SERVICE & PARTS TECHNICAL INFORMATION

April, 1979

CYLINDER HEAD GASKETS

TR7

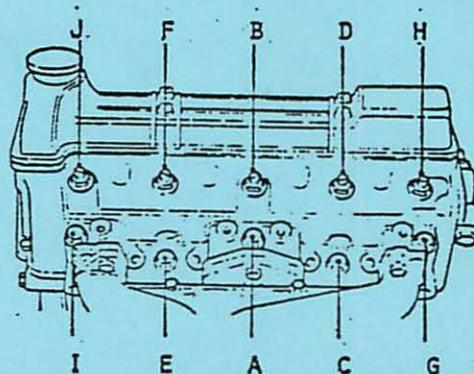
The following torque and cylinder head tightening sequence must be used when fitting cylinder head gasket, part no. GEG 3304.

TORQUE 45-50 lbs/ft.
